**ADDENDUM NO. 3**

FOR: WEBB COUNTY YOUTH VILLAGE REHABILITATION CENTER  
FOR WEBB COUNTY  
111 CAMINO NUEVO ROAD, HWY 359  
LAREDO, TEXAS 78041

ADDENDUM DATE: July 6, 2016

ARCHITECTS PROJ. NO.: 1401

**AM1.1**  
 DATE: JUNE 29, 2016

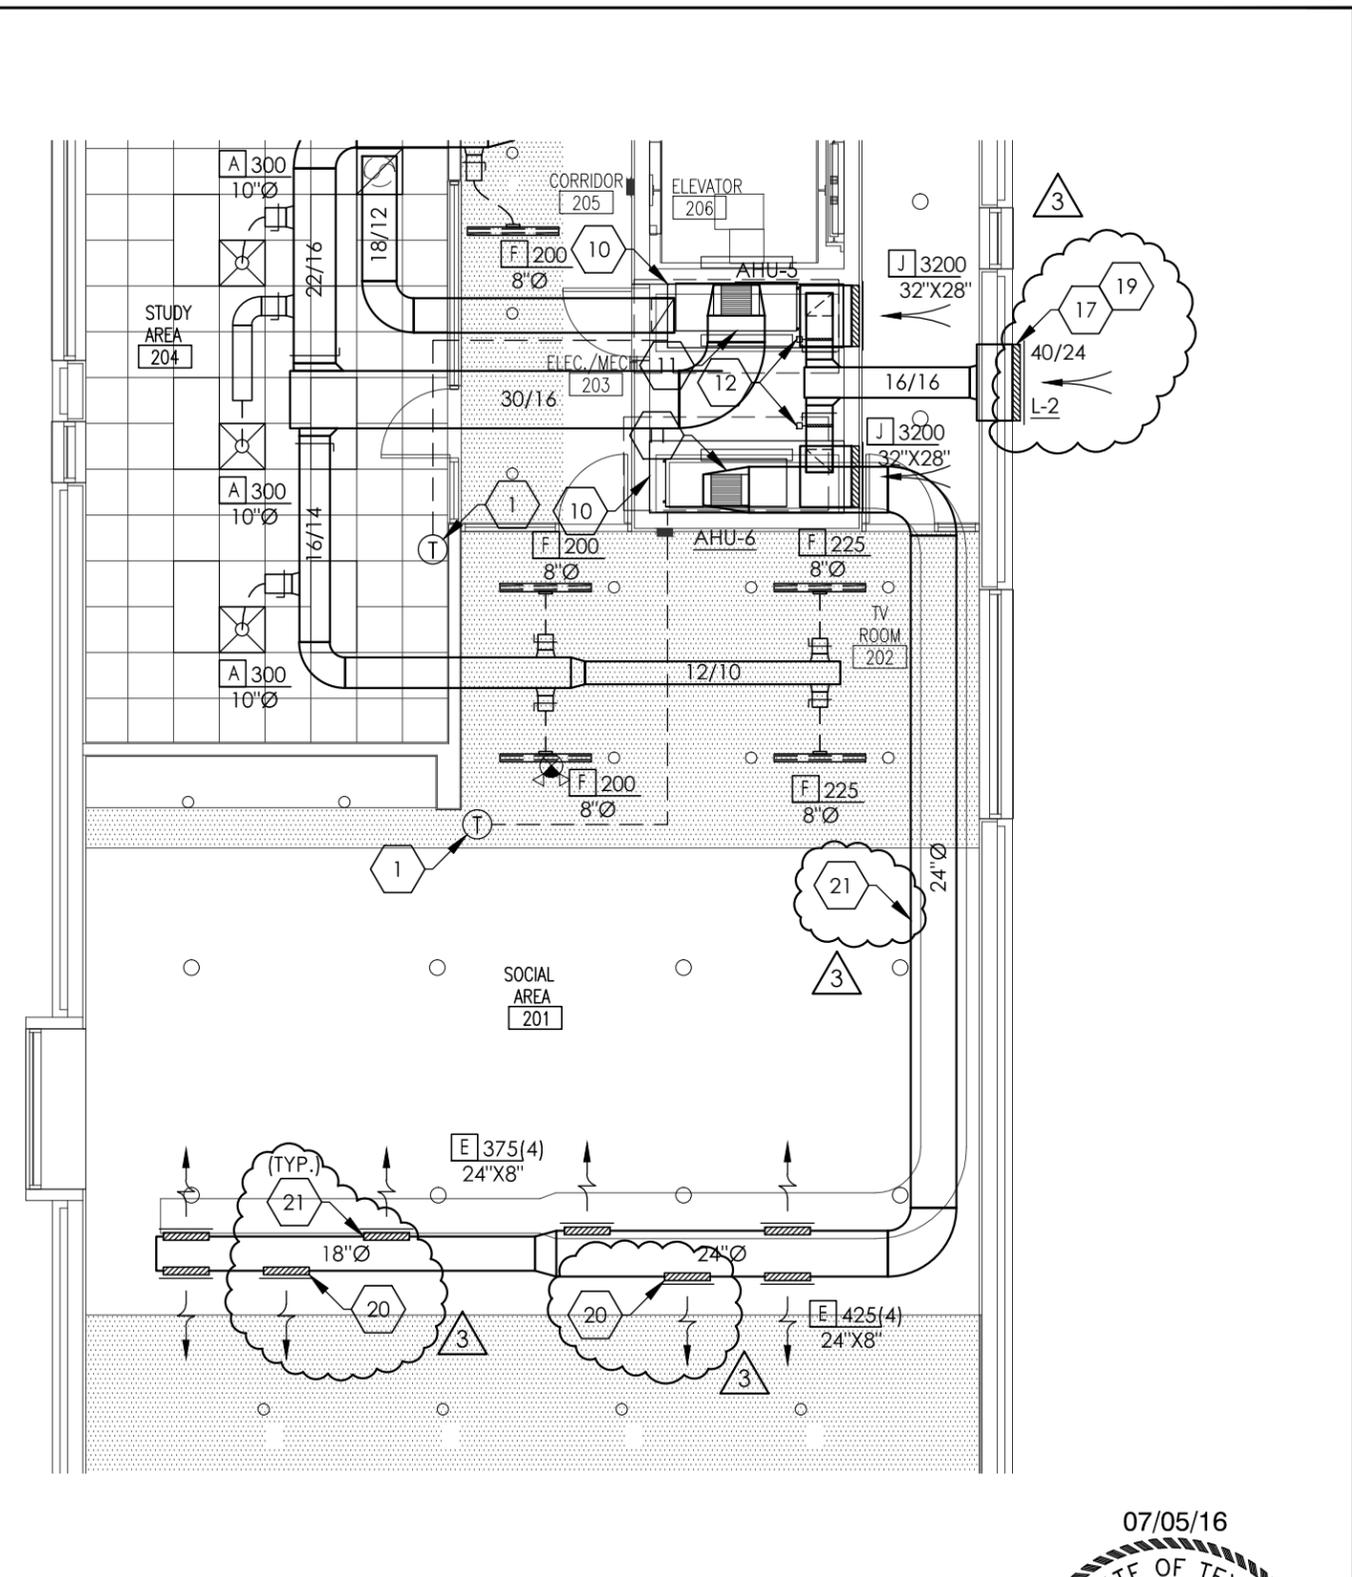
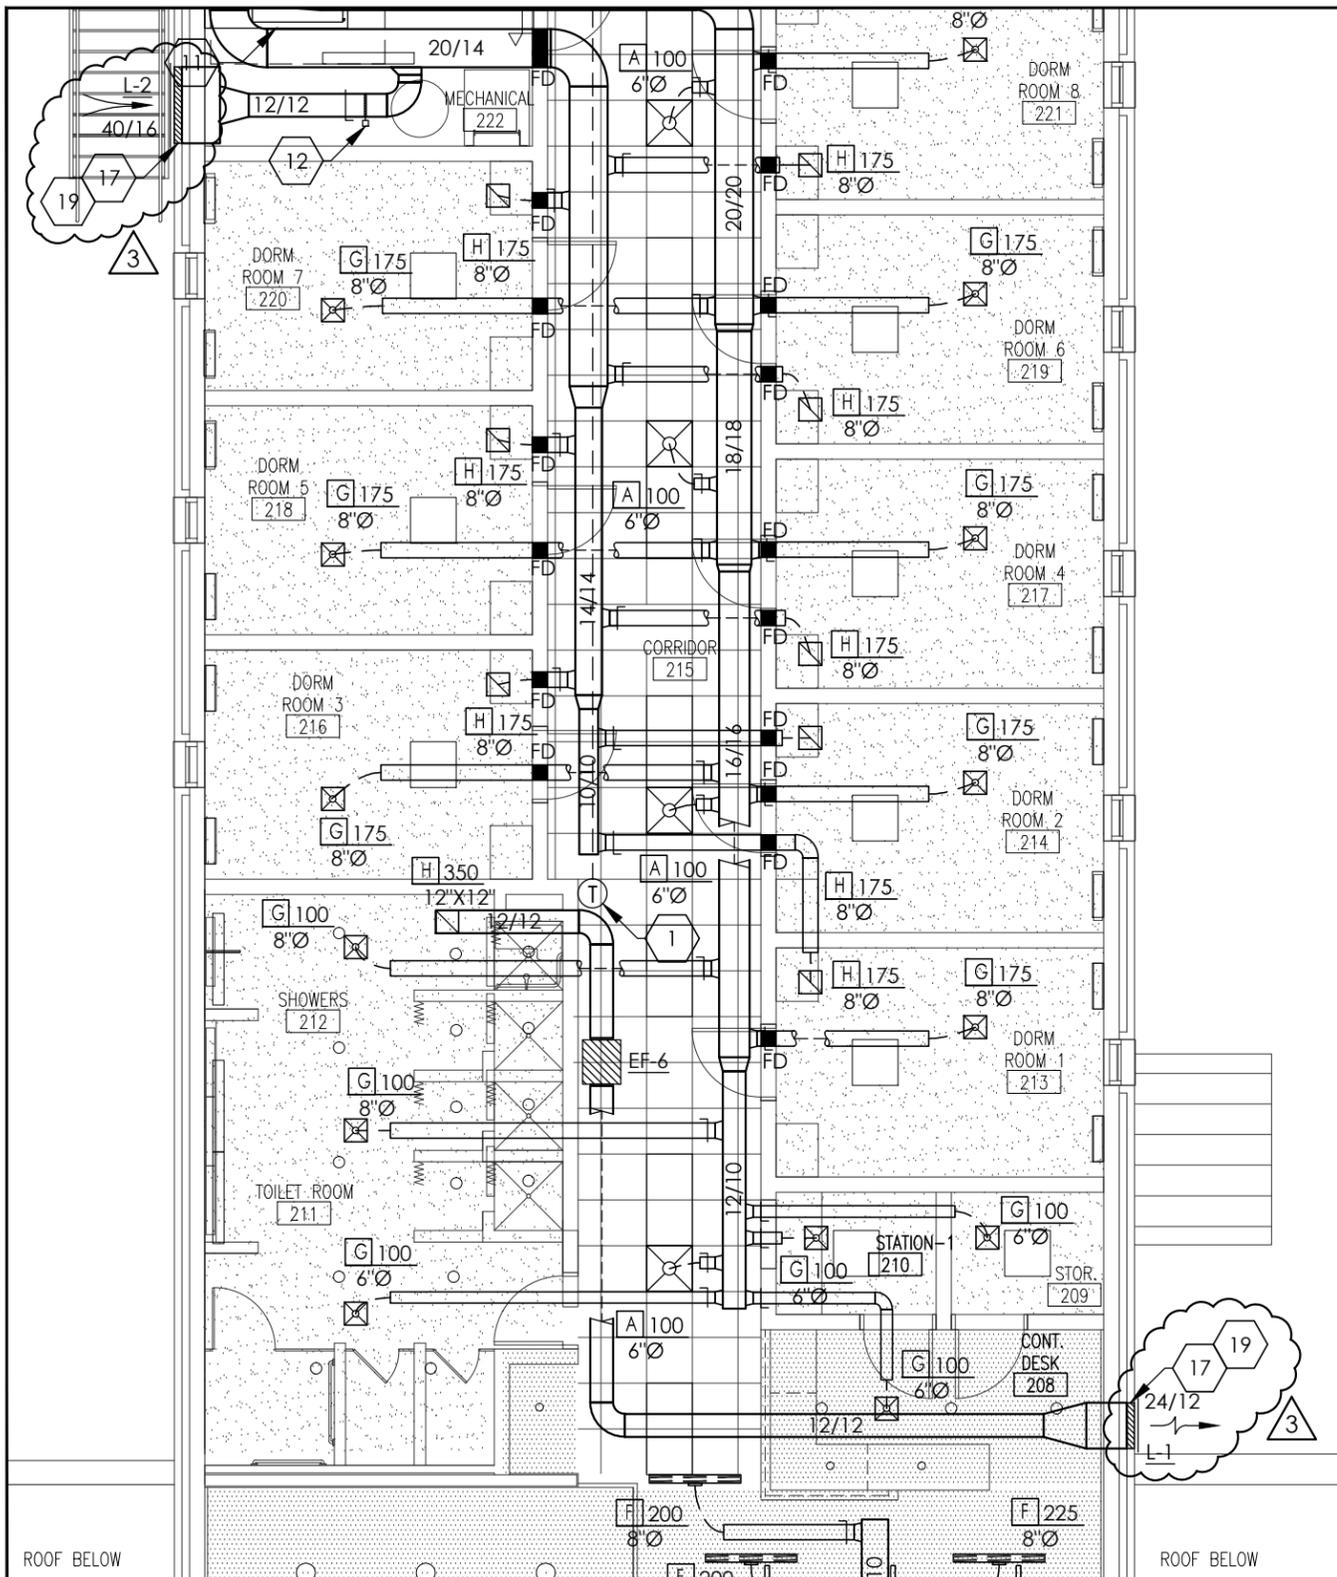
<b>Item</b>	<b>Reference Drawing(s)</b>	<b>Description</b>
D3-1	M1.1	<ol style="list-style-type: none"><li>1. Add keyed note No.21; refer to attached AM1.1</li><li>2. Revise keyed note No.8; refer to attached 1/AM1.1</li><li>3. Revise location of transfer air on Office 118; refer to attached 1/AM.1</li><li>4. Revise location of intake louvers; refer to attached 1/AM1.1</li><li>5. Revise supply air ductwork taps onto Office 128 &amp; 129; refer to attached 1/AM1.1</li></ol>
D3-2	M1.2	<ol style="list-style-type: none"><li>1. Add keyed notes No.19, 20 &amp; 21; refer to attached AM1.2</li><li>2. Revise mounting locations for supply air devices in Social Area 201; refer to attached 1/AM1.2</li><li>3. Revise location of intake &amp; exhaust louver heights; refer to attached 1/AM1.2</li></ol>
D3-3	M3.1	<ol style="list-style-type: none"><li>1. Revise Detail No. 1 to reflect metal AHU platform in lieu of wooden platform; refer to attached 1/AM3.1</li></ol>

**AE1.2**

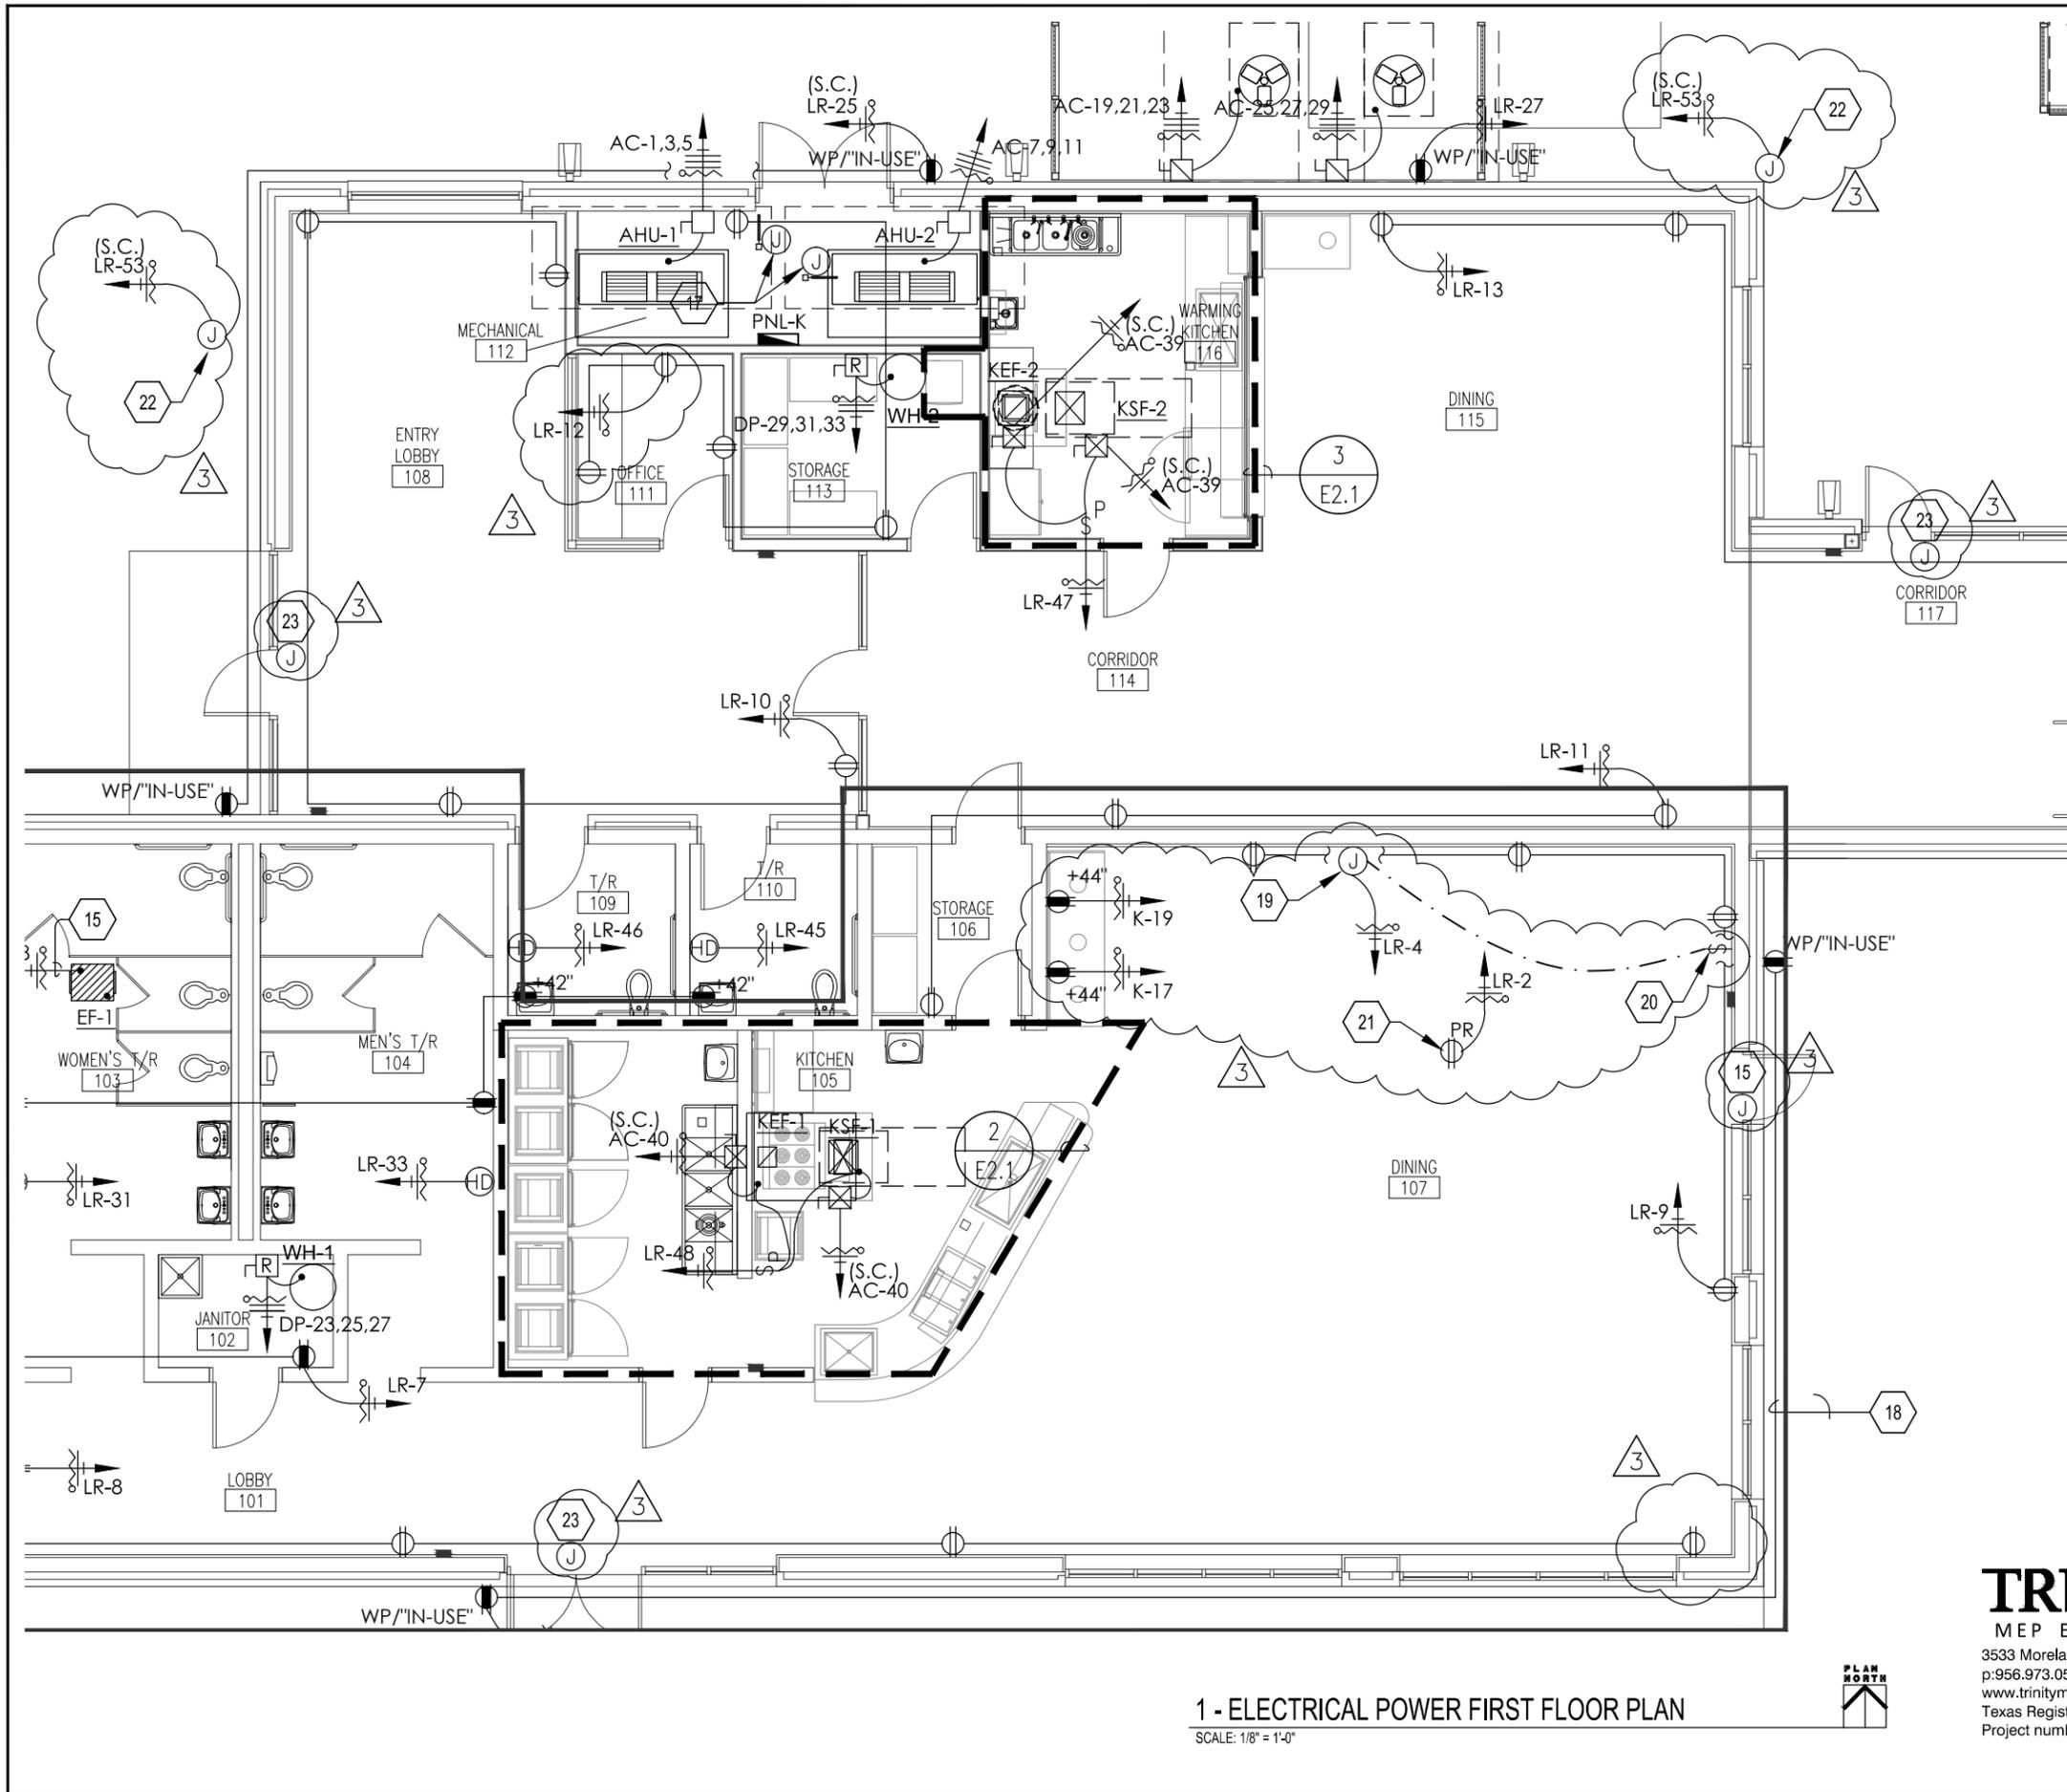
D3-6	E1.2	<ol style="list-style-type: none"><li>1. Revise as shown in attached sheet AE1.2</li><li>2. Add keyed note No.4; refer to attached AE1.2</li><li>3. Revise wall switch at TV Room 202; refer to attached 1/AE1.2</li><li>4. Add notes at Elevator 206; refer to attached 1/AE1.2</li><li>5. Revise lighting types at Corridor 215; refer to attached 1/AE1.2</li></ol>
D3-7	E2.1	<ol style="list-style-type: none"><li>1. Revise as shown in attached sheets AE2.1-A &amp; AE2.1-B</li><li>2. Revise notes at Dining 107; refer to attached 1/AE2.1-A</li><li>3. Add General Notes: Power, item H; refer to attached AE2,1-B</li><li>4. Add Keynotes: Power, items 19-23; refer to attached AE2.1-B</li><li>5. Revise outlet locations as shown in attached sheets AE2.1-A &amp; AE2.1-B</li></ol>
D3-8	E2.2	<ol style="list-style-type: none"><li>1. Revise a shown in attached sheet AE2.2-A &amp; AE2.2-B</li><li>2. Add General Notes: Power item H; refer to attached AE2,2-A</li><li>3. Add Keyed Notes; Power items 8-15; refer to attached AE2.2-A</li><li>4. Revise outlet locations at Dorm Rooms typical as shown in attached sheets AE2.2-A</li></ol>
